**Project/File: Millwell Place Subdivision/ BPP15-0031/ SUB15-0064**

*This is a preliminary plat application to allow for the development of 68 building lots and 2 common lots on 17.97 acres. The site is located at 6512 W. Saxton Avenue in Boise, Idaho.*

**Lead Agency:** City of Boise**Site address:** 6512 W. Saxton Avenue**Staff Approval:** December 30, 2015

## SITE PLAN

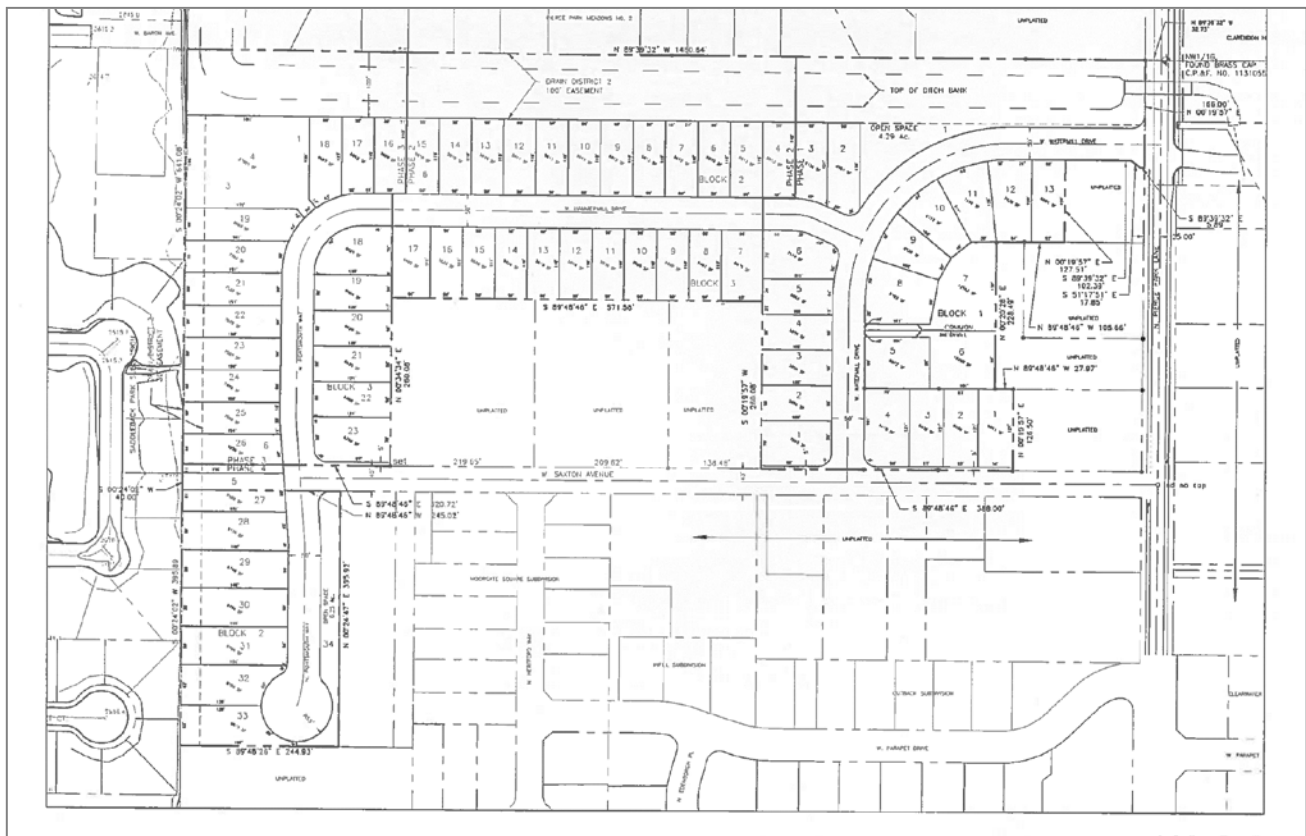
The applicant has proposed to vacate the portion of Saxton Avenue west of the proposed Portsmouth Way. This portion of Saxton Avenue is currently an unimproved right-of-way which stubs to an existing single family home in a developed subdivision. Staff is supportive of this proposal. The applicant should be required to apply to vacate the right-of-way when needed for the development of the site. The vacation is a separate application and approval process.

- d. **Staff Comments/Recommendations:** The applicant's proposal meets District policy and should be approved, as proposed. The cul-de-sac turnaround should provide a minimum radius of 45-feet.

- d. **Staff Comments/Recommendations:** The applicant's proposal to construct Millwater Drive to intersect Pierce Park Lane approximately 125-south of the north property line does not meet District policy, which requires local streets intersecting collectors to align or offset by 330-feet. Millwater Drive is proposed to offset Barron Lane by approximately 235-feet. However, staff recommends a modification of policy to allow Millwater Drive to be located as proposed. Staff's recommendation is due to the fact that the site does not have enough frontage to meet to the required offset. Staff 's recommendation is a 23% modification of policy and is approved at the Manager level.

1. Construct vertical curb, gutter, and a 7-foot wide attached concrete sidewalk on Pierce Park Lane abutting the site, as proposed.
2. Construct Saxton Avenue as half of a 36-foot street section, plus 12-feet of additional pavement with rolled curb, gutter, and a 5-foot wide attached concrete sidewalk abutting the site. Dedicate 5-feet of right-of-way (to total 25-feet) to accommodate this improvement.

3. Widen the offsite portions of Saxton Avenue between Portsmouth Way and Pierce Park Lane to 24-feet of pavement with 3-foot wide gravel shoulders.
4. Apply to vacate the portion of Saxton Avenue west of the proposed Portsmouth Way. The vacation is a separate application and approval process.

5. Construct all of the internal local street as 36-foot streets with rolled curb, gutter, and 5-foot wide attached concrete sidewalks within 50-feet of right-of-way, as proposed.

6. Construct one cul-de-sac turnaround with a minimum radius of 45-feet at the terminus of Portsmouth Way, as proposed.
7. Construct one roadway onto Pierce Park Lane, Watermill Drive, located approximately 125-south of the north property line, as proposed.

8. Construct one roadway on to Saxton Avenue, Watermill Drive, located approximately 500-feet west of Pierce Park Lane, as proposed.
9. Direct lot access to Pierce Park Lane is prohibited and shall be noted on the final plat.
